MONTGOMERY COUNTY PLANNING DEPARTMENT
THE MARYLAND-NATIONAL CAPITAL PARK AND PLANNING COMMISSION

MEMORANDUM

REVIEW TYPE: Preliminary Plan of Subdivision (Resubdivision)

PROJECT NAME: Miracle Temple Assembly of God
CASE #: 120080290
REVIEW BASIS: Chapter 50, Montgomery County Subdivision Regulations

Figure 2

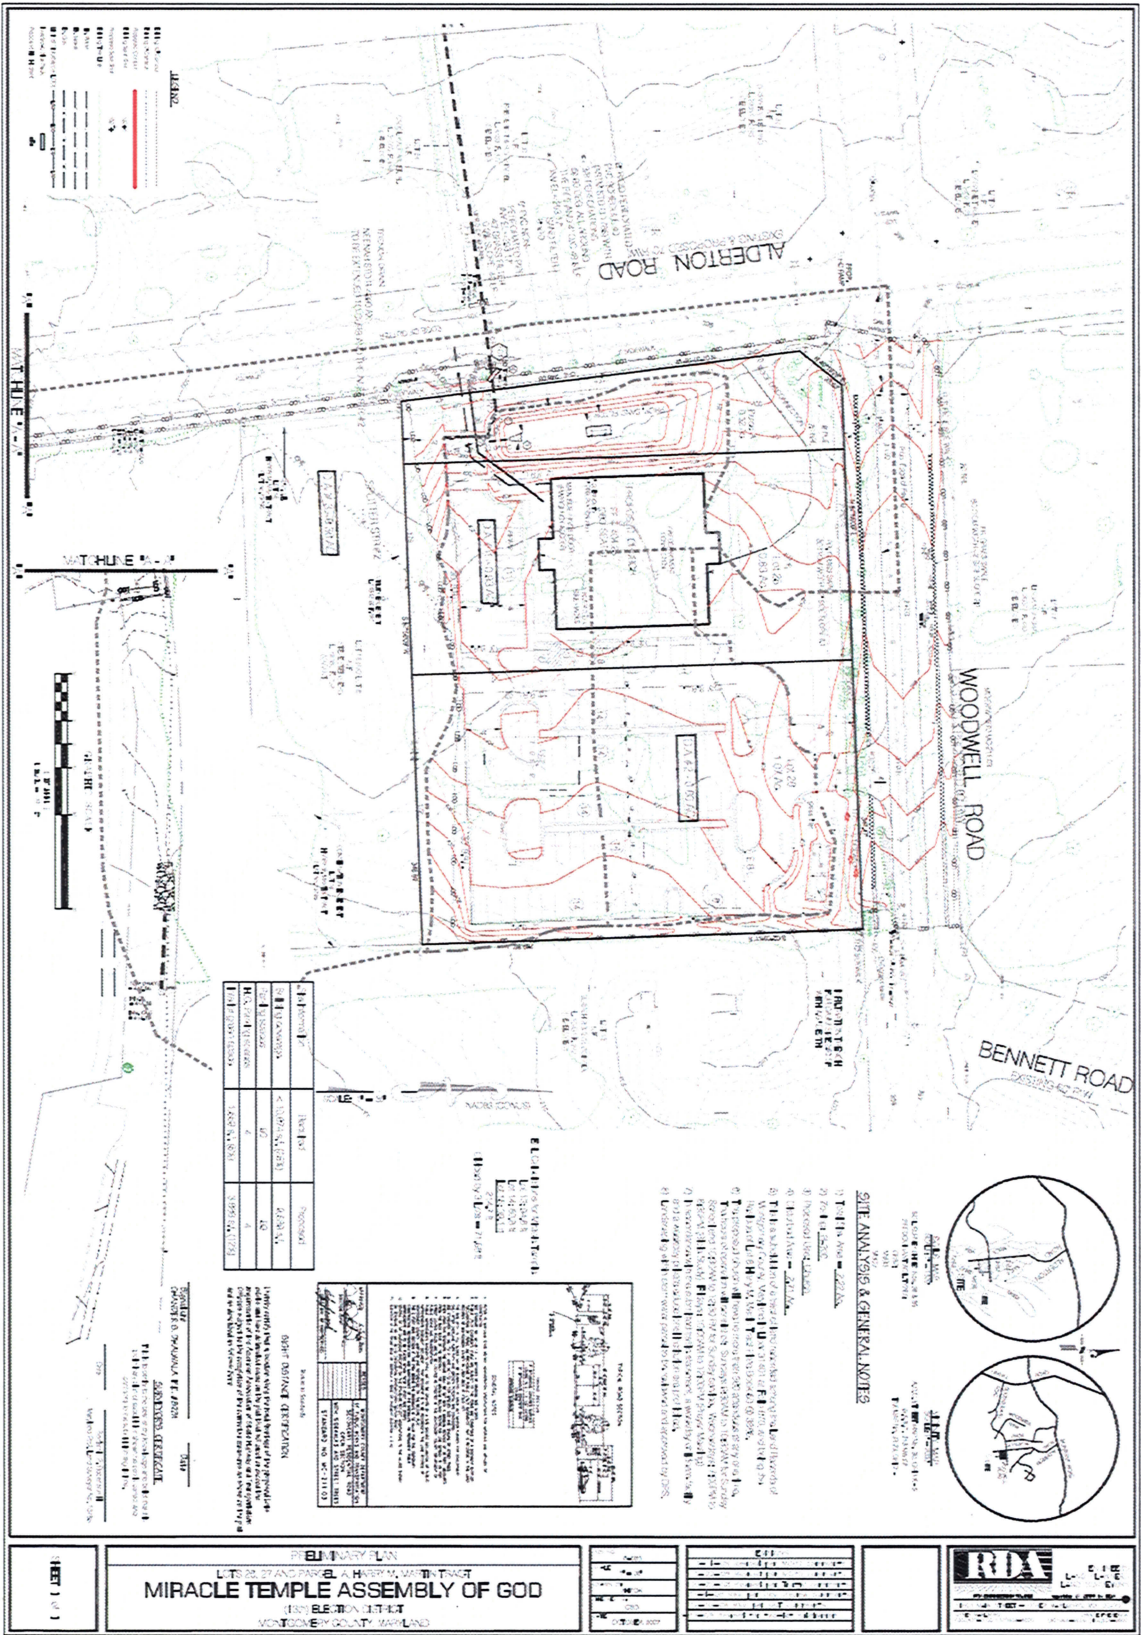
The application proposes to resubdivide the part of a lot into two lots and one stormwater management parcel; one lot will be 36,156 square feet in size and the other will be 46,609 square feet in size. The proposed use on the lots is for a religious institution with a capacity of 360 seats and its associated parking, both of which are permitted uses within the R-200 zone. This facility will operate on weekends only; there will be no weekday educational classes nor will there be a weekday child day care operation. The Pastor has stated that there will be an evening Bible study on Wednesday evenings. Access to the church will be at two locations, one on Woodwell Road and the other from Alderton Road.

The application has an approved stormwater management concept dated August 29, 2007. Because the building and parking were shifted slightly to achieve proper setbacks with the two lot plan, a revised stormwater management concept was submitted and approved by MCDPS on July 31, 2009. The concept consists of on-site infiltration via sand filters and trenches, and channel protection measures via on-site detention using a shallow pond. The application meets the requirements of Chapter 50-24(j) for stormwater management.

RECOMMENDATION: Approval subject to the following conditions:

- 1) Approval under this preliminary plan is limited to two lots for one house of worship with a maximum of 360 seats and associated parking with no weekday education facilities or weekday daycare.

- 3) The Applicant must comply with the Landscape Plan revised on March 17, 2009, and must further modify the plan to include a lighting plan for staff approval, prior to issuance of building permits.

- 4) Prior to recordation of the plat, the Applicant must meet all MCDPS requirements to ensure the final construction, as part of this development, of an 8 ft. wide shared use path within the public street right-of-way along the property frontage of Alderton Road, as recommended by the draft ICC Functional Master Plan. The certified preliminary plan must be correctly reflect this trail.
